# SUBMISSION

25 APRIL 2024

RE: DA 2024/0363  
13 ACACIA ROAD SEAFORTH  
WRITTEN SUBMISSION: LETTER OF OBJECTION  
SUBMISSION: TULLOCH

### **THE UPPER-LEVEL MASTER BEDROOM DECK**

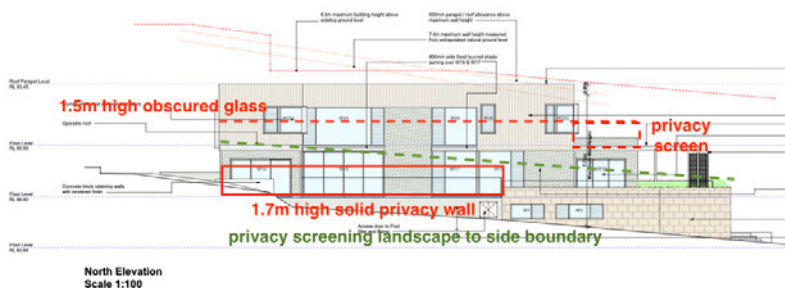
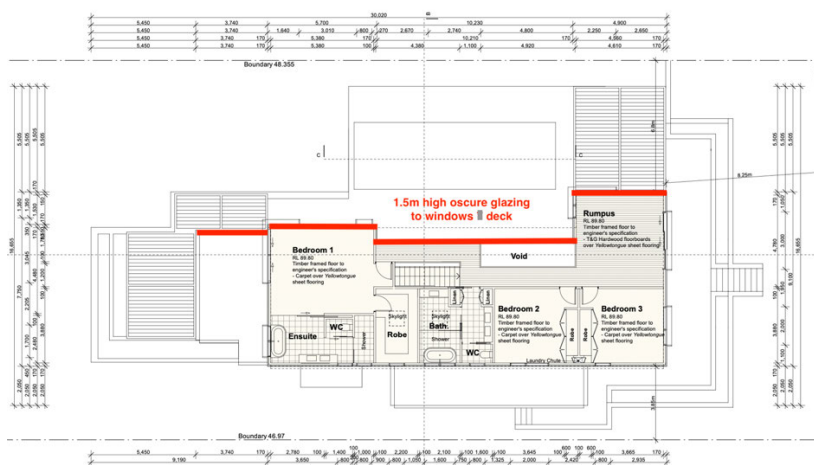
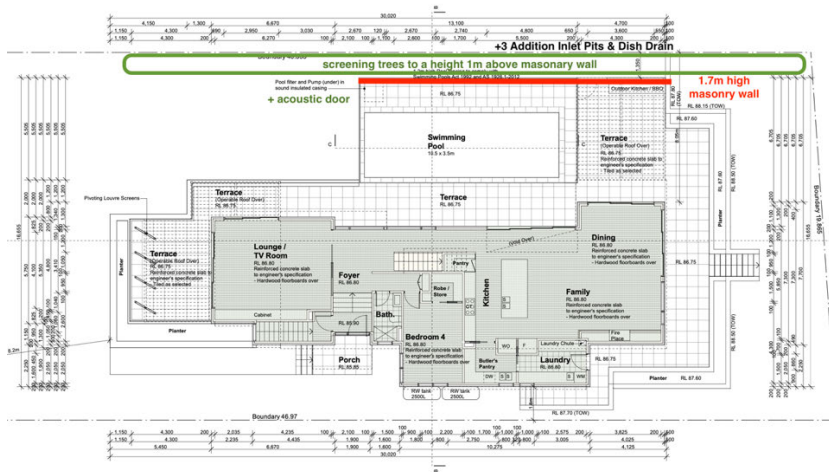
The proposed development has an extensive north facing deck directly facing my client's private open spaces and windows.

**REQUEST 3:** To overcome this privacy problem my client asks that that the Master Bedroom Deck be fitted with a 1.5m high obscured/translucent glazing privacy screen

## 2. SURFACE STORMWATER CONTROL

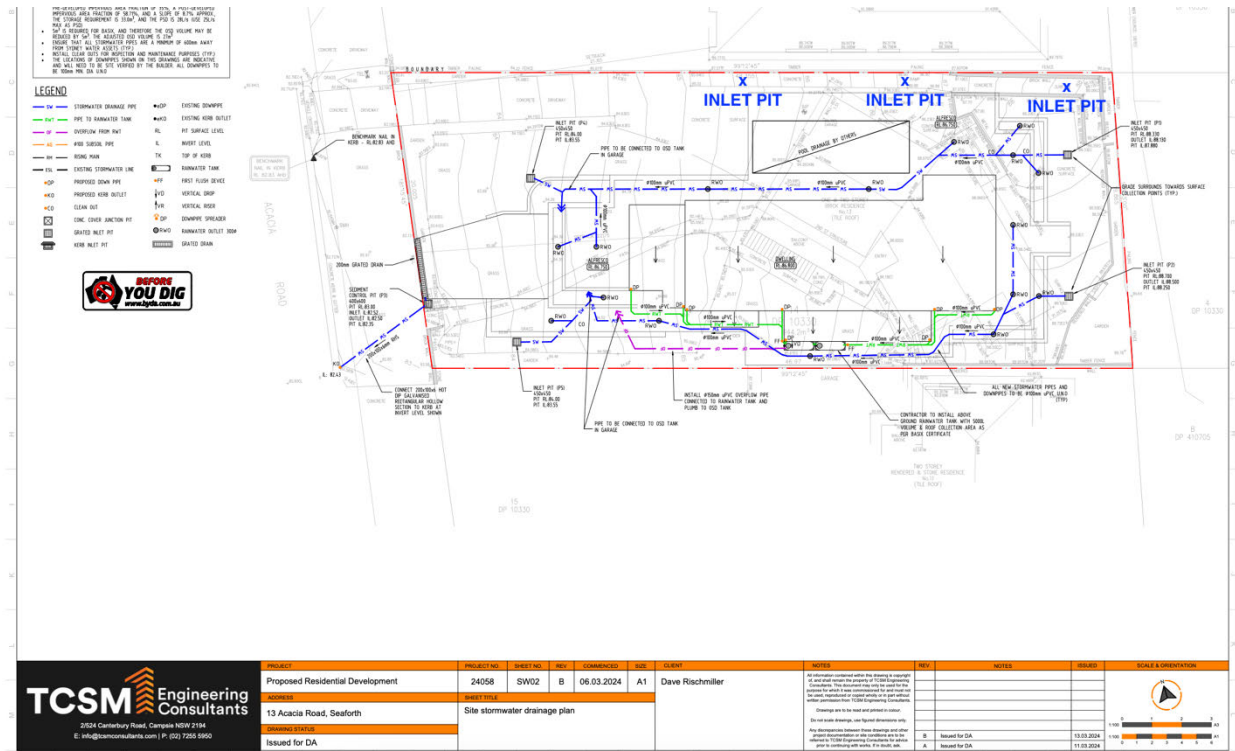
My client advises that there is uncontrolled surface stormwater that requires collection along the common boundary.

**REQUEST 4:** My client asks for three additional Inlet Pits to be positioned along the boundary with a concrete dish drain to contact to each Pit to collect the surface water.

*TCSM Amendment: Position three additional Inlet Pits with connecting dish drain*
